CITY OF KELOWNA
MEMORANDUM

DATE: September 16, 2005
TO: City Manager
FROM: Planning & Corporate Services Department
APPLICATION No.: Z05-0029
OWNER: Tony Balisky
APPLICANT/CONTACT PERSON: D E Pilling & Associates Ltd./ David Pauls
LOCATION: 1240 Band Road
PURPOSE: To rezone from the A1 – Agriculture 1 zone to the RU1 – Large Lot Housing zone
EXISTING ZONE: A1 – Agriculture 1
PROPOSED ZONE: RU1 – Large Lot Housing zone
REPORT PREPARED BY: Shelley Gambacort

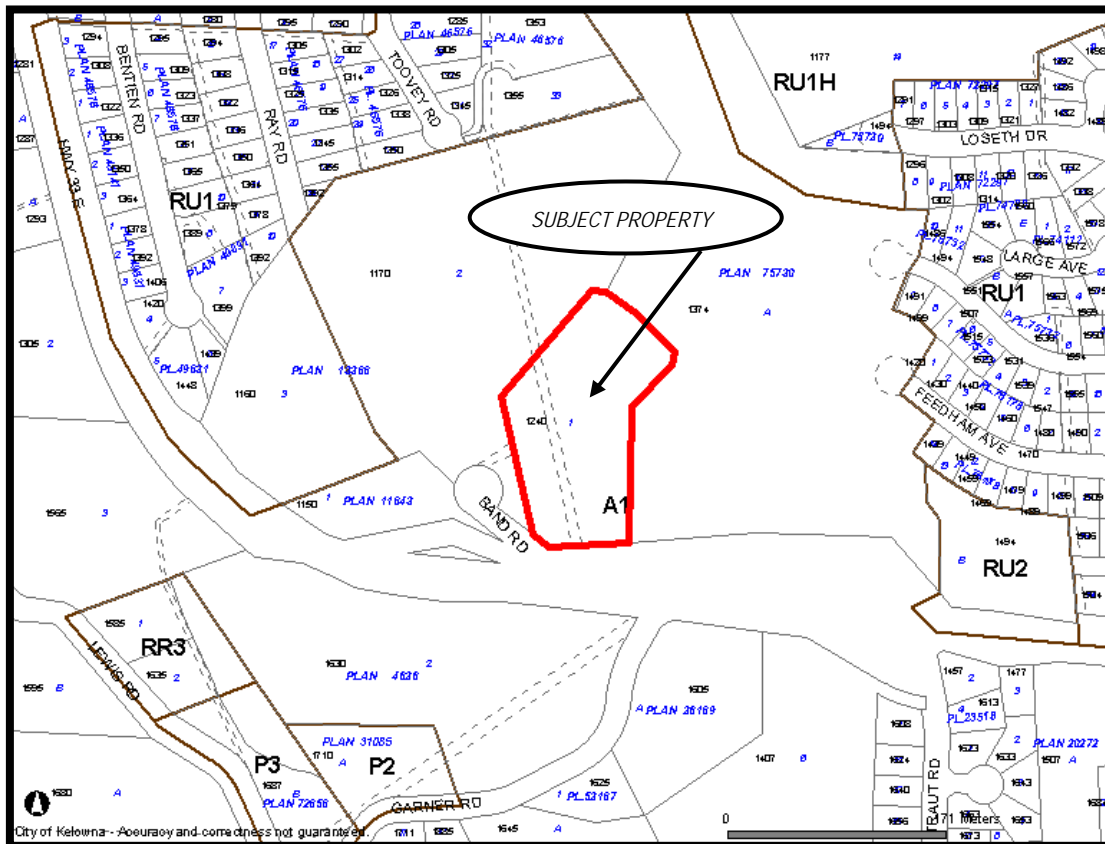
There will be no direct access permitted from the proposed lots to Highway 33. Development of the upper lots will be subject to the provision of the proposed road through the property to the east. The development of the lower lots will require the realignment of the intersection across from Garner Road at Highway 33 to the satisfaction of the Ministry of Transportation.

There are currently two homes on the subject property and the proposal is to retain the home that is located at the south end of the property and remove the home located at the north end of the property.

- a) Provide a comprehensive plan showing the layout for the entire area, including preliminary profiles to ensure that it will all fit nicely in the end. There are several concepts and they do not all seem to achieve the same goal with regard to the overall development and connectivity.

- a) 'Ray Road' connection to Highway 97 is required. A temporary connection from Band Road is not recommended by Works and Utilities due to the added traffic to a substandard and blind intersection with Hwy 33. The proposed development should be done in conjunction and incorporated with the new proposed intersection at

Garner Road which would require the dedication of a right of way on the property located to the east of the proposed development.

- No direct access to Highway 33 for any of the proposed lots, all access to be gained via a municipal street.
- Registration of a suitably worded restrictive covenant on the subject property that no development of proposed lots 1 - 9 will proceed without the construction of the fourth leg of the Garner Road / Highway 33 intersection.
- With the construction of the fourth leg of the Garner Road / Highway 33 intersection, the existing Band Road at Highway 33 is to be removed and then connected with the new fourth leg of Garner Road.

No objection however there will be some difficulty in providing water to it as a stand alone project. A connection to the 900 mm watermain in our easement at west side will be required, located at proposed road G. This would provide water to lots 10 through 18 only. A temporary watermain design could be achieved as an interim measure to service lots 1 - 9 until the property to the east is developed. A watermain design by client's engineers would be previewed in this aspect. The proposed development would be subject to:

As the subject property is outside of an urban centre the required building setback would be 15 m and in order to facilitate the development of proposed Lots 2, 3, & 4 this requirement would need to be reduced down to 7.5 m, which is the rear yard setback requirement for the RU1 – Large Lot Housing zone. The rear property line is presently ranging from 30 – 40 m from the edge of the highway.
